Subject: Davis-Besse Nuclear Power Station
Supplemental Information for Technical Specification Change regarding Technical Specification 3/4.7.1.7, "Motor Driven Feedwater Pump System" to Correct the Safety-Grade Designation of the Motor Driven Feedwater Pump Flow Indication in Surveillance Requirement 4.7.1.7.e.2 (LAR 03-0001, TAC No. MB9017).

Davis-Besse Nuclear Power Station (DBNPS)
License Amendment Request 03-0001
Motor Driven Feedwater Pump System Flow Indicator
- Responses to NRC Questions -

DBNPS Updated Safety Analysis Report
Annotated Figure 10.4-12A
Auxiliary Feedwater System

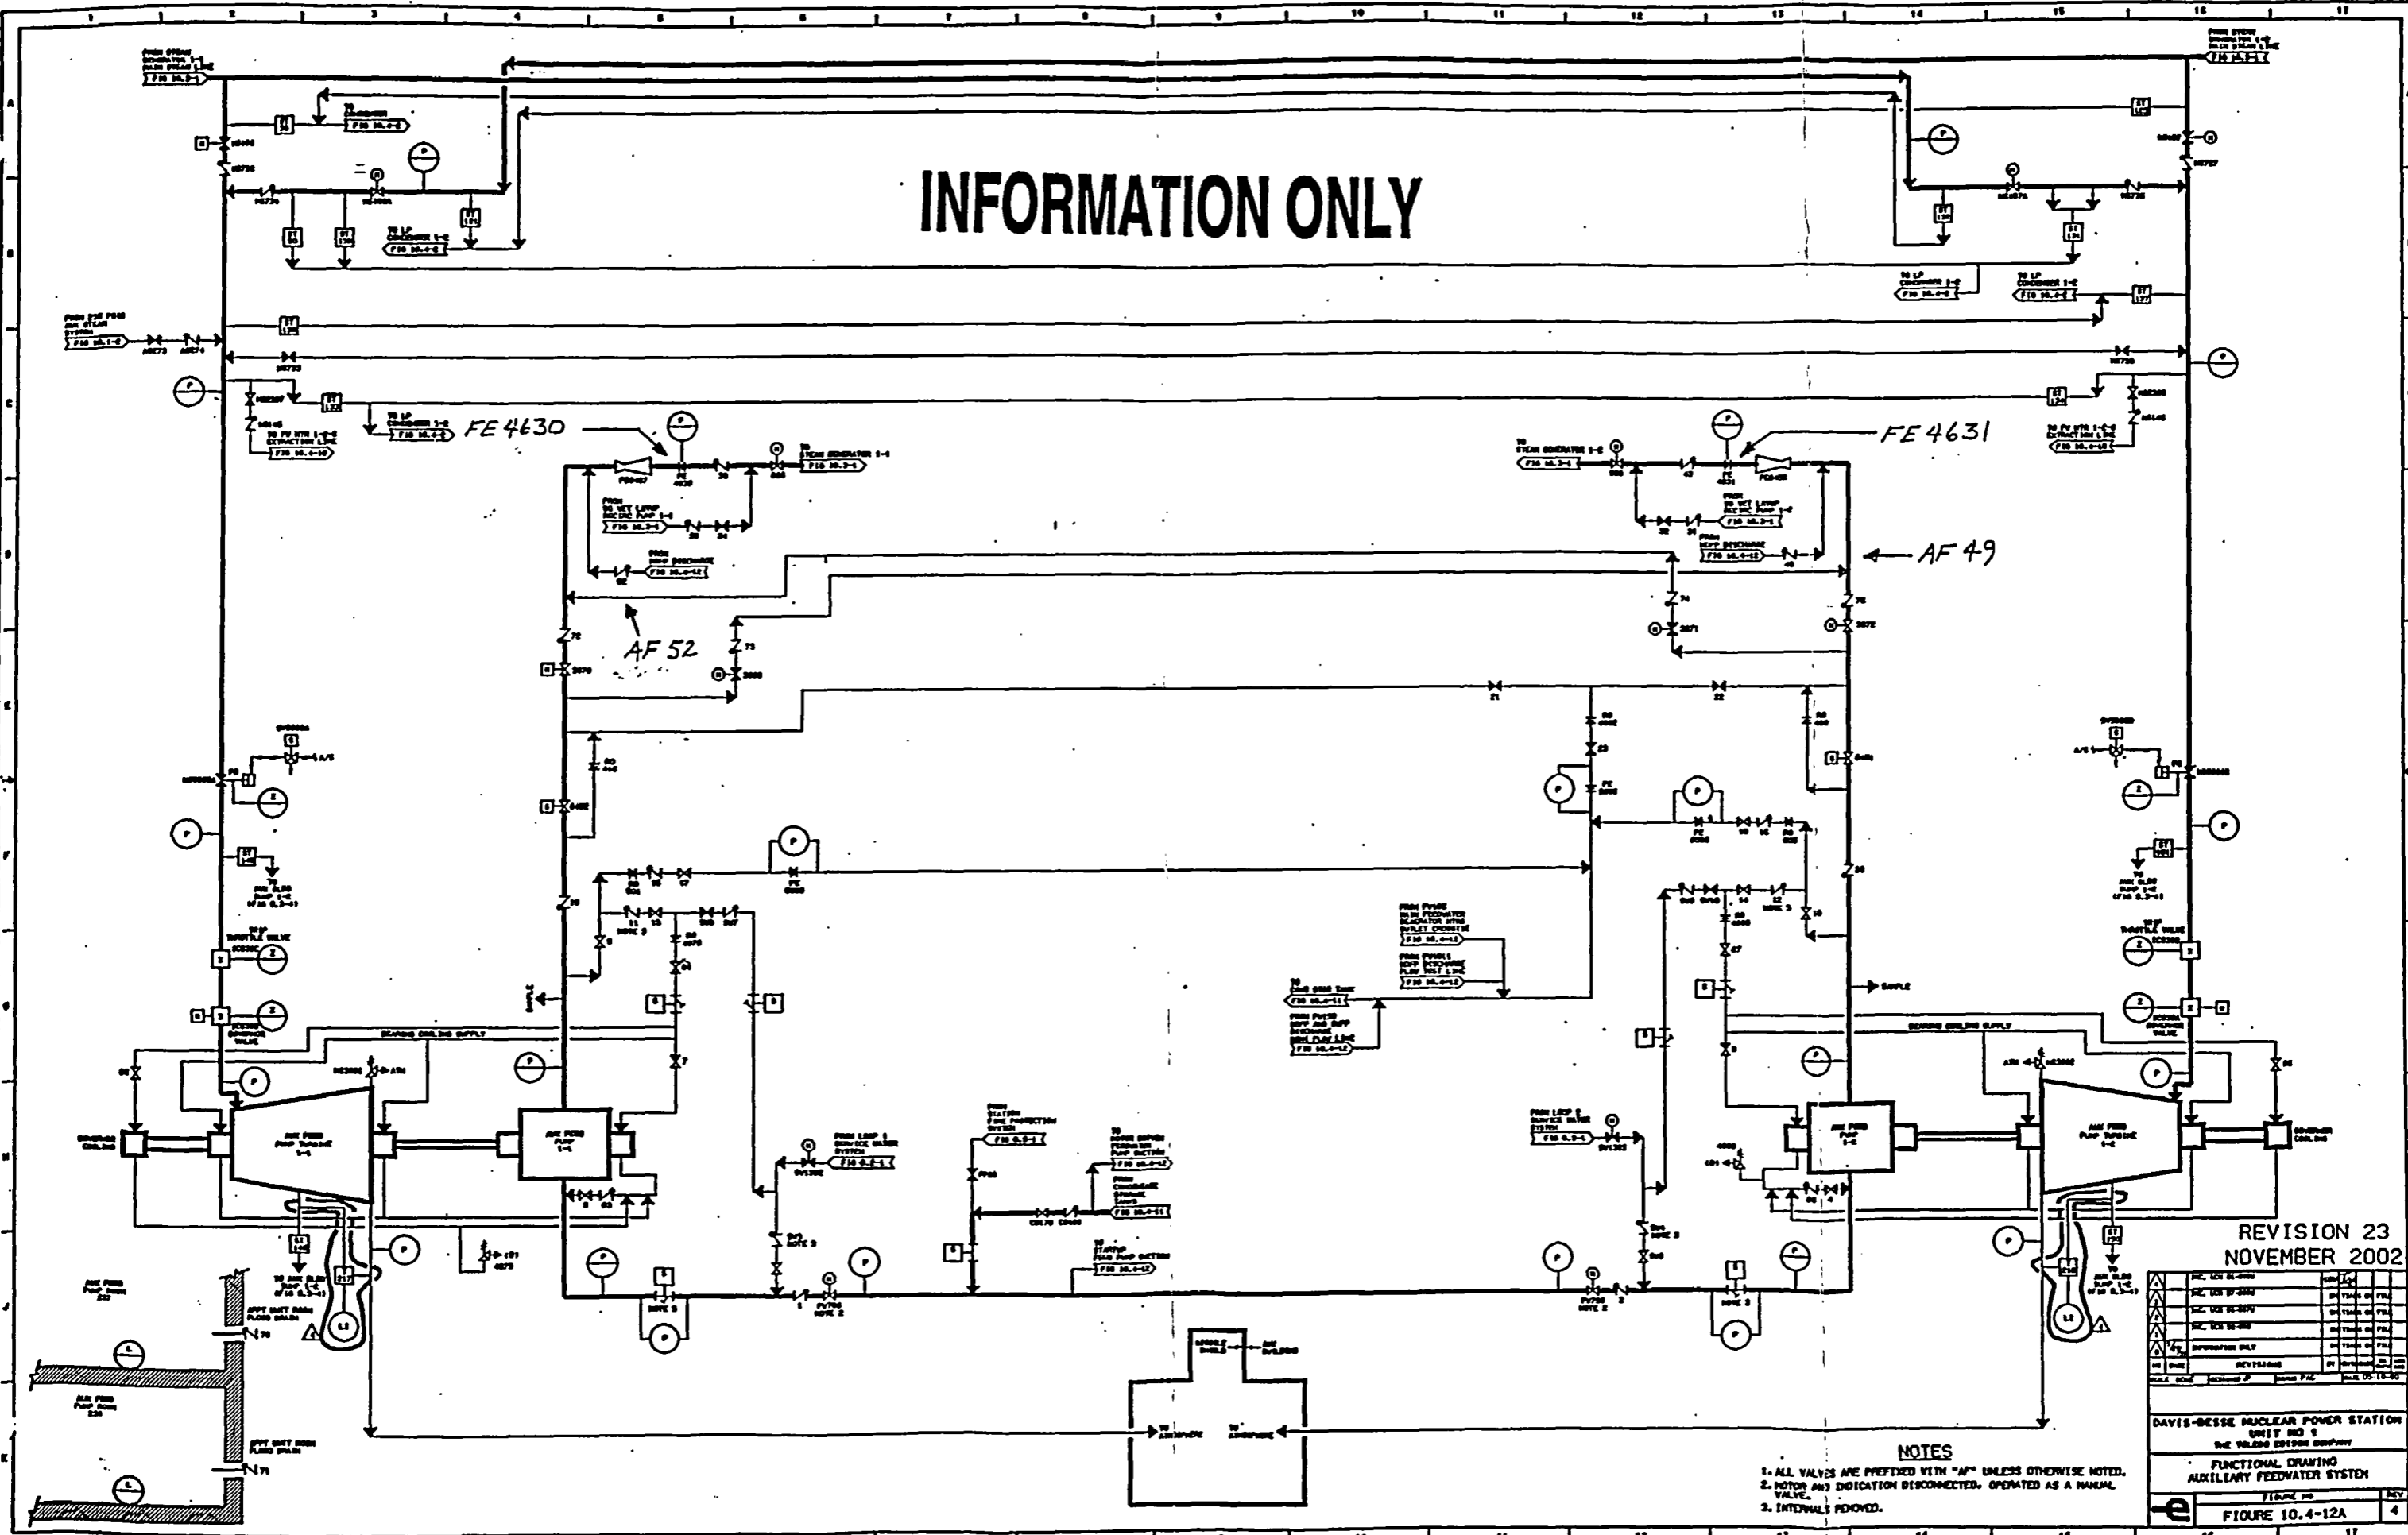
Demonstrate that there is no safety reason for the original requirement that the flow indication be SG [Safety Grade]. Include a discussion of all SG/nonSG interfaces for the AFW [Auxiliary Feedwater] System.

The only AFW System interfaces potentially affected by the proposed change are those with the MDFP System. As shown on USAR Figure 10.4-12A (annotated copy enclosed), the MDFP System interfaces with the safety-grade AFW System at check valves AF49 and AF52, which prevent backflow from the AFW System to the MDFP System. The MDFP System and the AFW System also share a non-safety grade test flow line to the condensate storage tanks.

The MDFP discharge pipe connection to the safety-grade AFW system is upstream of the safety-grade flow indication associated with the AFW piping to each steam generator as shown on USAR Figure 10.4-12A. Accordingly, if the MDFP is in operation and providing feedwater to the steam generators, the flow will be indicated by safety-grade indication FE/FI 4630 for steam generator 1-1 and safety-grade indication FE/FI 4631 for steam generator 1-2. These two safety-grade flow indicators are tested under TS SR 4.3.3.6. The AFW System Flow path is demonstrated operable by using these flow indicators under TS SR 4.7.1.2.1.c, 4.7.1.2.1.f, and 4.7.1.2.1.g.

MDFP SR 4.7.1.7.e.2 is a situational-type SR, and is required to be performed only as a post-modification or repair test when the modification or repair is upstream of the MDFP test flow line tie-in to the non-safety related condensate storage tanks. It is not used to determine safety grade flow to the steam generators. Accordingly, there is no safety reason that the MDFP FE/FI 5876 flow indication be safety grade.
